02 PROPOSED SECOND FLOOR PLAN

21-802

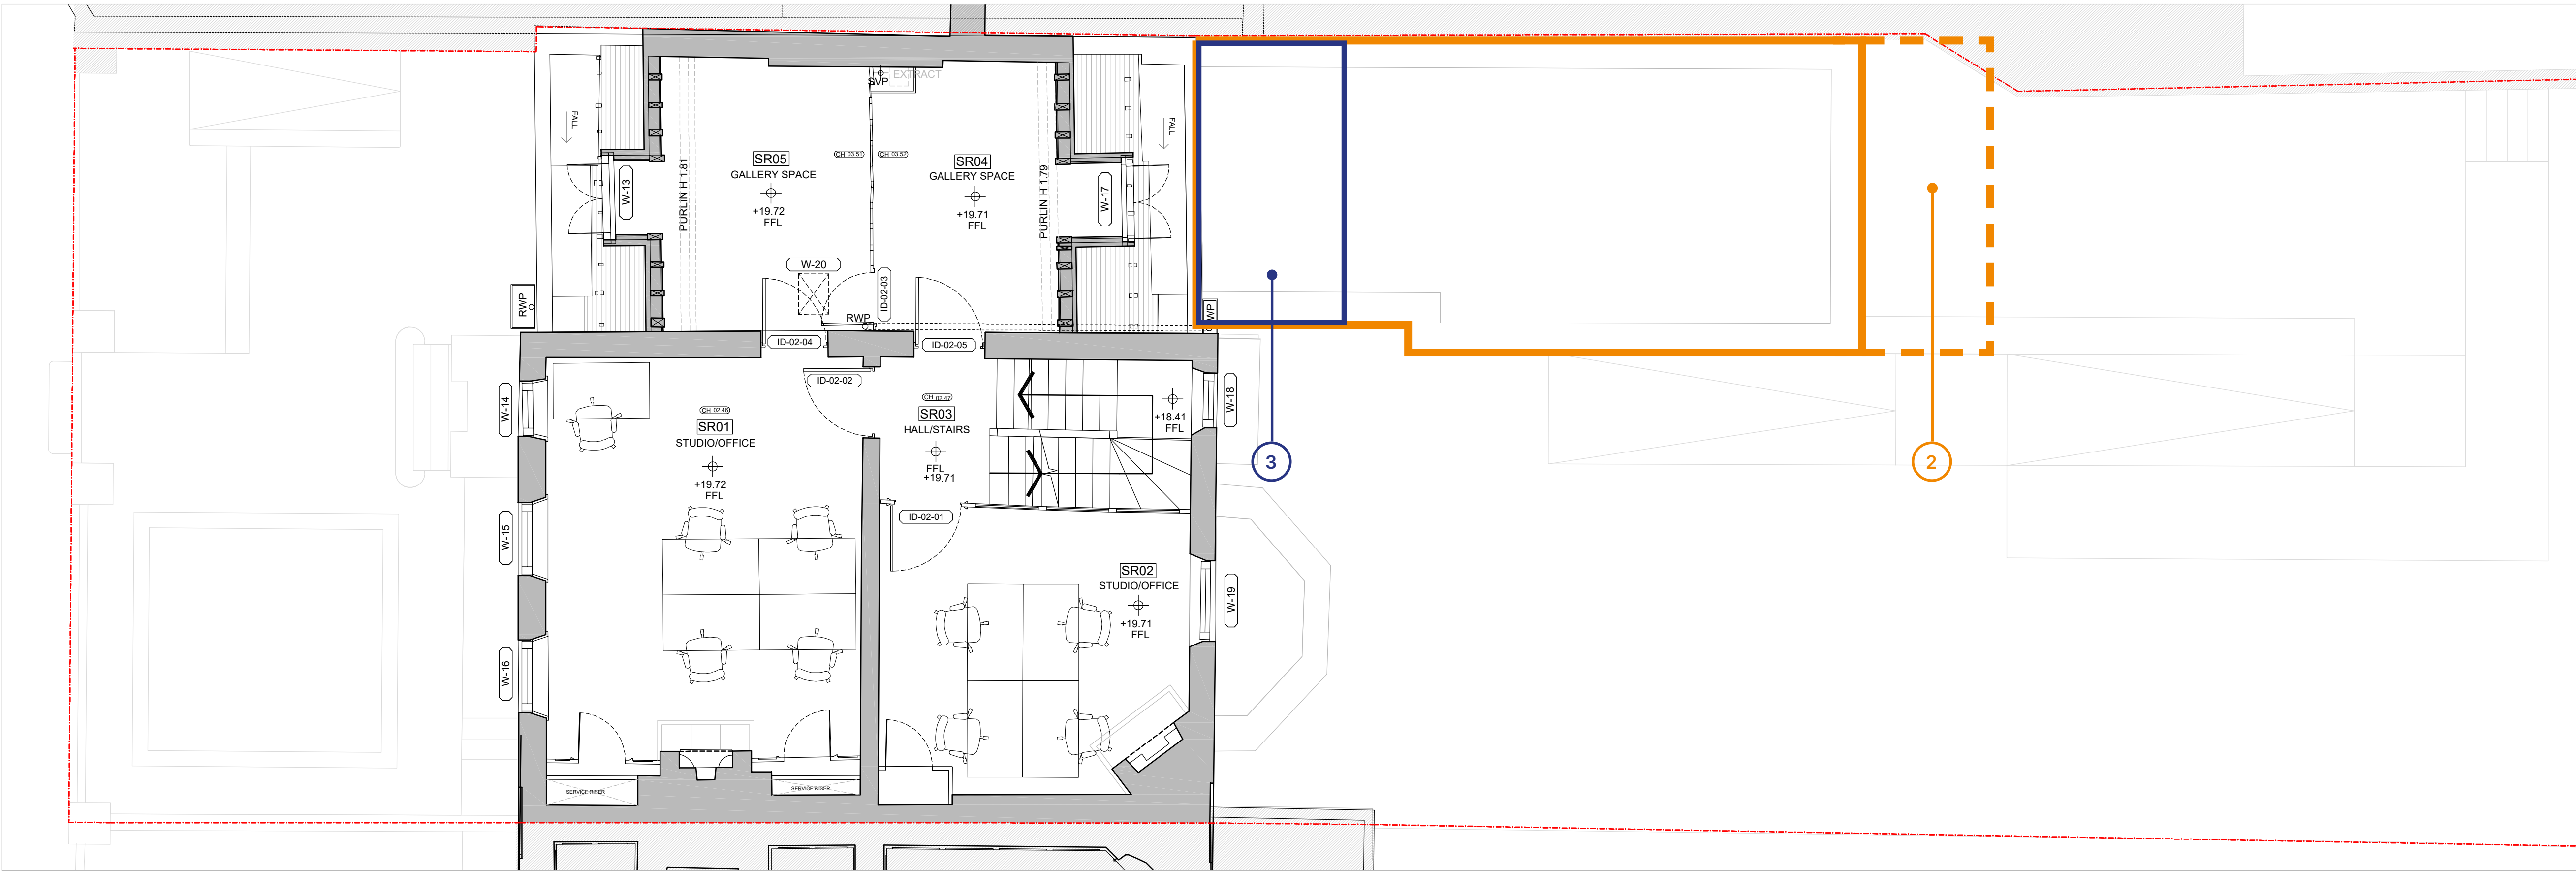
1. Existing floor level retained, steps and platform lift omitted – rear addition façade extended down to ground level.
2. Consented single storey rear addition extended by 1.5m, to the east.
3. Junction between existing building and rear extension altered with addition of glazed link – associated roof geometry altered.
4. Landscaping revised to suit café extension at grade level.
